Powerhouse Ultimo Renewal

Stormwater and Flooding Response to SSDA Authority Comments

“Stormwater and Flooding, Response to State Significant Development Comments”, PU2-REP-CI-00X03[B]

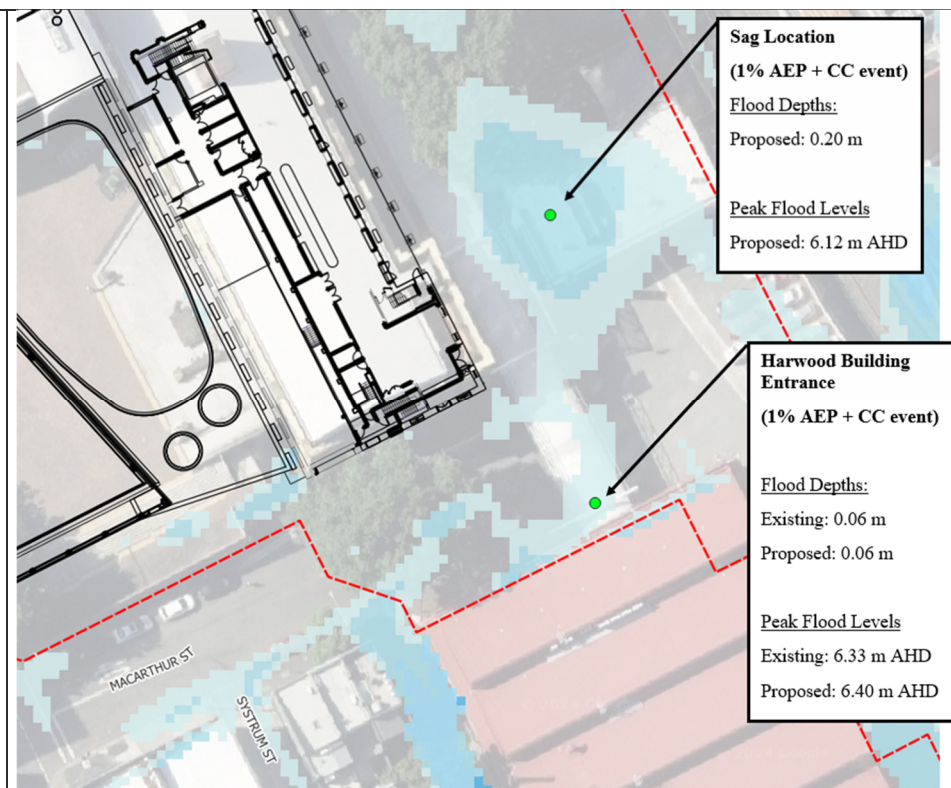
Item	Agency Comment	Response
Biodiversity, Conservation and Science		
<p>1</p> <p>Flood impacts north of the Harwood Building</p>	<p>BCS notes significant flooding outside the roller doors on the north side of the Harwood Building, as shown in dark orange below. BCS requests additional information on the impacts at this location, which have been observed during multiple flood events. It is crucial to avoid any flood impacts that could create or exacerbate over-floor flooding in neighbouring properties.</p> 	<ul style="list-style-type: none"> The increases in peak flood levels outside the Harwood Building referred to in the BCS Comment 1 are due to the proposed road surface level being raised from existing, rather than an increase in flows outside the Harwood Building. Whilst the peak flood levels reported in the flood model are higher than existing (6.33 m AHD in existing vs. 6.40 m AHD in proposed), peak flood depths are similar between existing and proposed (0.06 m in both existing and proposed). Whilst the proposed surface level is higher than existing outside the Harwood building, the proposed surface grades away from the Harwood building (as per existing), towards the sag point approximately 30m north of the Harwood Building. The localised sag point approximately 30m to the north of the Harwood Building entrances (which is drainage by an inlet pit) has a ground elevation of 5.90 m AHD and the peak flood level in the 1% AEP + CC is 6.12 m AHD. The grading of the design surface maintains the surface flows draining along Macarthur Street, noting these are relatively shallow, will drain away from the Harwood Building entrances towards the adjacent sag point. <p>Noting the above, we believe the proposed does not materially increase the existing flood risk to the Harwood Building.</p>

Recommended action:

- Provide additional details on the anticipated flood impacts at the roller doors, specifically regarding the proposed increase in water levels. The figures alone don't provide a clear understanding of the proposed flood levels at this location.
